## FIELD OBSERVATION REPORT PERMIT # BLDC-00620-2022

Report No. 37	Page 1 of 2
Project:	Oceans West One Condominium	Inspection For:	Building Repair and WP Project
Day/Date:	Friday, November 4, 2022	Job No.	20-1153
Location:	1 Oceans West Blvd. DBS, FL 32118	Engineer:	Christopher B. Longman, P.E.
Contractor:	SPEC Contractor Services	Project Foreman:	Alberto
Subcontractor:	None	Inspector:	Christopher B. Longman, P.E.
Weather:	75 Degrees @ 9:05 A.M.	Partly Cloudy	Light Breeze 40% Chance of Rain
Workforce Total:	17		
Activities:	Punchout 02/03 balcony stack Tower B and 05 window wall Tower A

Photograph #1: Completed waterproofing and painting at a balcony on the 03 balcony stack

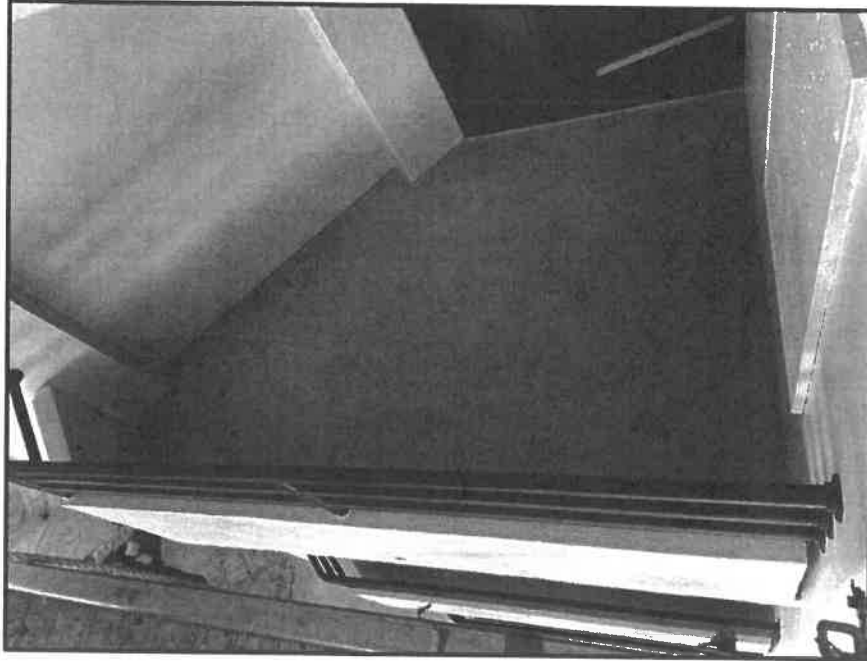
**Tower B:** The Contractor requested a final punchout inspection for the completed painting and waterproofing at the 02/03 balcony stack. The painting application was professional in appearance with no holidays observed. Deck coating at the 02/03 balcony was evenly applied and continued up the cant bead as specified. The following items were brought to the Foreman's attention to be corrected at the 02/03 balcony stack: Unit 21B3-touch up paint on ceiling and clean shutters, 10B2-clean shutters, 7B2 clean paint off electrical outlet, 21B2-repair deck coating at cant bead, 20B3, 20B2, 12B2, 10B2, 9B2, 8B3, 7B2, 7B3, 4B2-clean paint off light fixture. The deck coating application at the 1<sup>st</sup> floor and the paint application at the South column are left to be completed at the 02/03 balcony stack and it was requested for the AC vents at the lower 3 elevations be touched up.
